South Texas Project
Units 3 and 4
Docket Nos. 52-012 and 52-013
Revised Responses to Requests for Additional Information

1. Question 09.02.05-7, Response Revision 1
2. Question 14.03.05-2, Response Revision 1

Figure 3.0-1 UHS and Reactor Service Water System

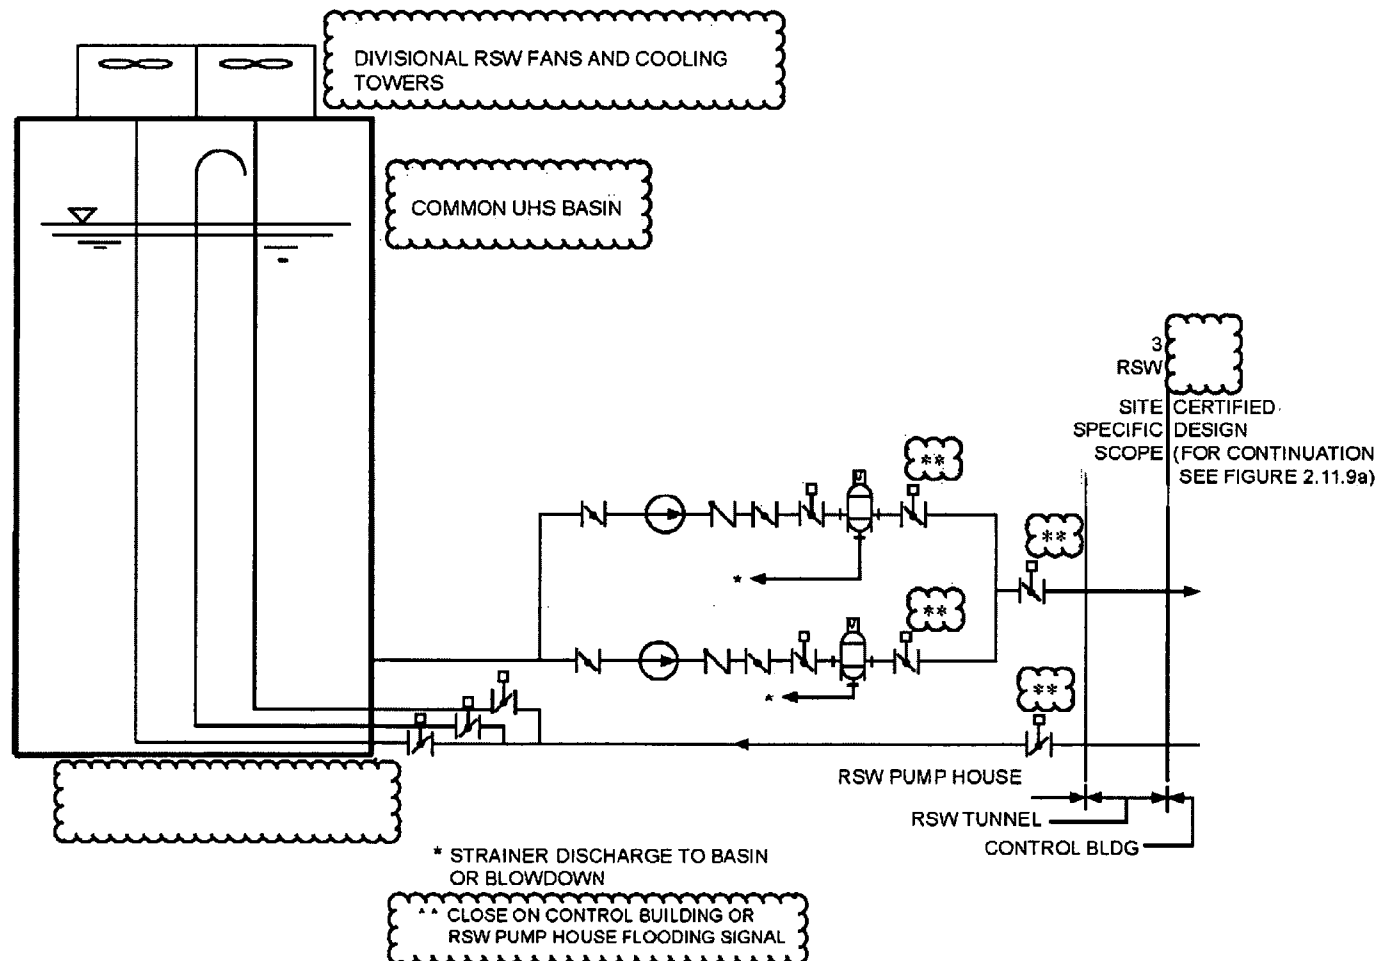
Please explain why the acceptance criterion as written does not address the 'required functions of the UHS system' stated in the design commitment and how the figure referenced provides sufficient information to allow the implementation of this ITAAC given that the figure lacks the required details.

Finally, NINA is providing additional details to COLA Part 9, Figure 3.0-1 which complements the changes described above. Deleted from the Figure is redundant information (3 RSW) that is correctly shown on Tier 1 Figure 2.11.9a.

As a result of this RAI response, COLA Revision 5, Part 9, Table 3.0-1 Item 4, Table 3.0-5 Items 5 and 7, and Figure 3.0-1, are revised as shown below by grey shading or bubbles:
